City Planning Department

Memo

To: Cranston City Plan Commission
From: Joshua Berry, AICP - Senior Planner / Administrative Officer
Date: July 2, 2021
Re: **Use & Dimensional Variance @ 68 Gansett Avenue**

Owner/App: Michele L. Caprio
Location: 68 Gansett Avenue, AP 7/5, Lots 2036
Zone: B-1 (Single and Two-family dwellings)
FLU: Single/Two-Family Residential Less than 10.89 units/acre

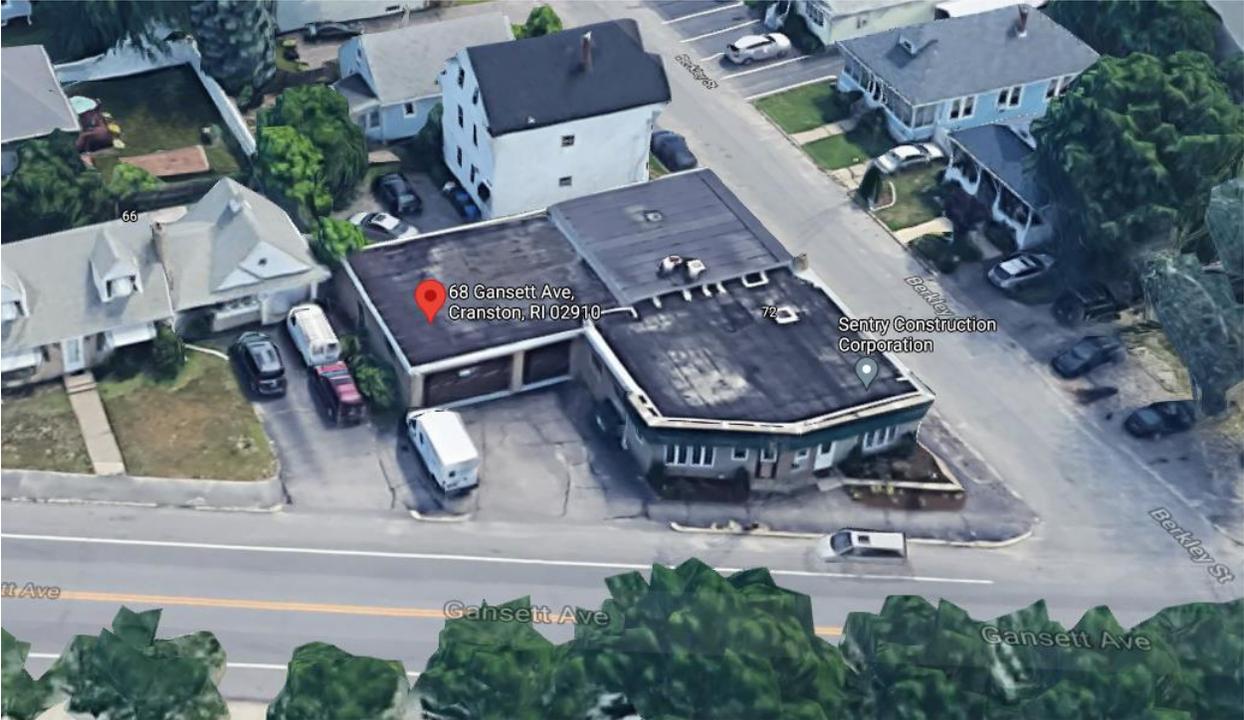
8. Converting the existing commercial building to a conforming residential use may be impractical and/or problematic.
9. The proposed wall signage is 10' wide x 2' high. Wall signs are not permitted in B-1 zoning. In neighborhood business districts, C-1 and C-2 zones, the maximum wall sign area is 30 ft². The proposed sign is 20 ft².

10. The proposed pole signage is 4' wide x 5' tall. The total height is unknown, roughly 8'-9' above the sidewalk. Freestanding signs are not permitted in B-1 zoning. In neighborhood business districts, C-1 and C-2 zones, the maximum freestanding sign area is 25 ft². The proposed freestanding sign is 40 ft² as area is calculated as the sum of each side.

11. The proposed freestanding sign appears to be in conflict with City Code Section 17.20.100 *Corner Visibility*, which prevents objects from obstructing line of sight on side corner lots.

Zoning relief is required for the proposed wall sign and the proposed freestanding sign as neither are permitted in B-1 zoning. The 20 ft² wall sign (10' wide x 2' high) is 33% less than the maximum area that would be allowed if this were a C-1 or C-2 zone. For this reason, staff does not take issue with the proposed wall sign. The proposed freestanding sign is 20 ft² per side for a total of 40 ft². In neighborhood business districts, C-1 and C-2 zones, the maximum freestanding sign area is 25 ft². There was a 4' x 4' sign hanging from the existing structure, but the applicant is not grandfathered to the sign because of the change of use and increase in size.

Another aspect of the application is that the proposed freestanding sign is not in compliance with City Code Section 17.20.100 *Corner Visibility*, which prevents objects from obstructing line of sight on side corner lots. Relief from this section was not itemized in the variance application so staff does not have the benefit of the applicant's justification for relief from this section. In absence of such, staff conducted a site visit and found that when driving westbound on Berkley Street, when one pulls up to the intersection with Gansett Ave, the freestanding sign is located *behind* the line of sight and therefore does not obstruct the view of the first car entering the intersection. This is in part due to the 8' wide sidewalk on Gansett Ave and 6'-8' sidewalk on Berkley Street, allowing the distance for the car to drive past the position where the sign may potentially obstruct the view (see the pictures on the following page). Additionally, although the dimension between the street and the bottom of the proposed sign is unknown, there appears to be adequate clearance underneath the bottom of the proposed sign would be. The fact that there was a 4' x 4' sign hanging from the same pole at the same location lends one to belief that it is not necessarily an imminent safety hazard. Staff is of the *opinion* that granting relief would not create a safety hazard, but would also remind the Commission that Planning staff does not have the qualified expertise to *definitively* make a conclusive statement regarding safety. The Traffic & Safety Bureau was unavailable for comment at this time.
